Piper Aircraft Corporation
Vero Beach, Florida, U.S.A.

SERVICE *No. 779B* BULLETIN

Date **October 12, 1987** **M**

SUBJECT: Landing Gear Upper Bearing
Retaining Pin Replacement and Strut
Assembly Inspection.

SKETCH "A"

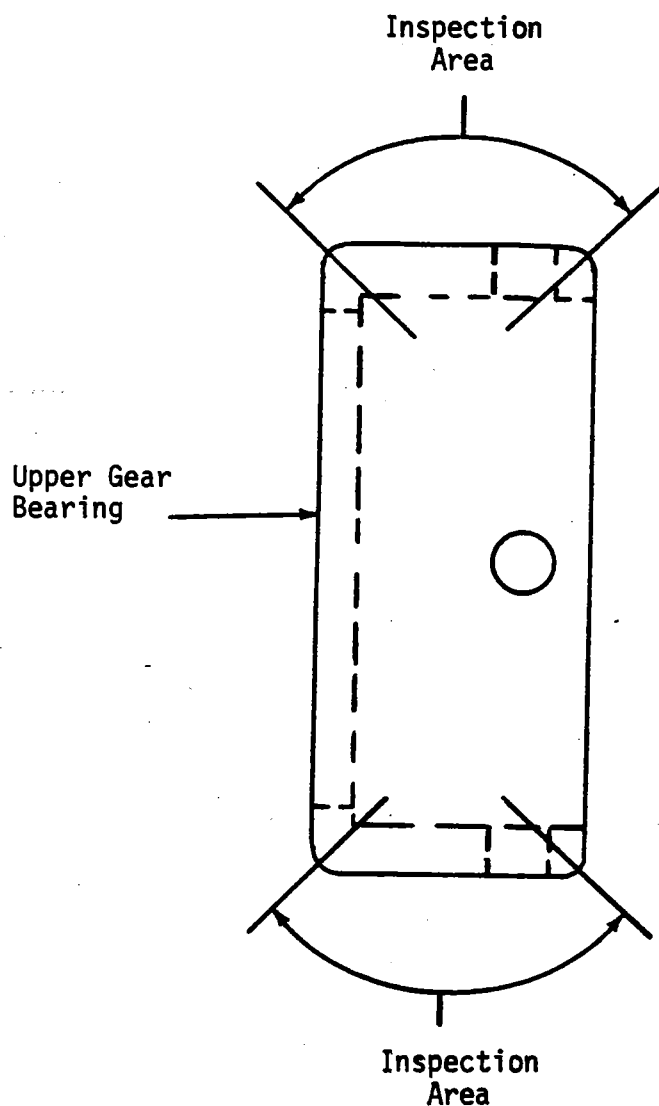
Remove the upper bearing and inspect the area shown in Sketch A.
If ridges are found in the designated inspection area, replace the bearing.
Any replacement bearing should also be inspected per Sketch A prior to installation.

Note: For All PA-31/31T/31P Series Aircraft, Upper Main Gear Bearing, Piper Part Number 40247-00 and/or Upper Nose Gear Bearing, Piper Part Number 31779-00. Inspection Area Must Be Chrome Plated And Have a Smooth Surface (No Ridges Allowed) Between Indicated Points on Entire Outside Surface.

For All PA-42 Cheyenne III Aircraft, Upper Main Gear Bearing, Piper Part Number 57470-02 and/or Upper Nose Gear Bearing, Piper Part Number 31779-02 are Manufactured of Bronze Alloy And Are Not Plated. Inspection Area Should Have a Smooth Surface (No Ridges Allowed) Between Indicated Points on Entire Outside Surface.
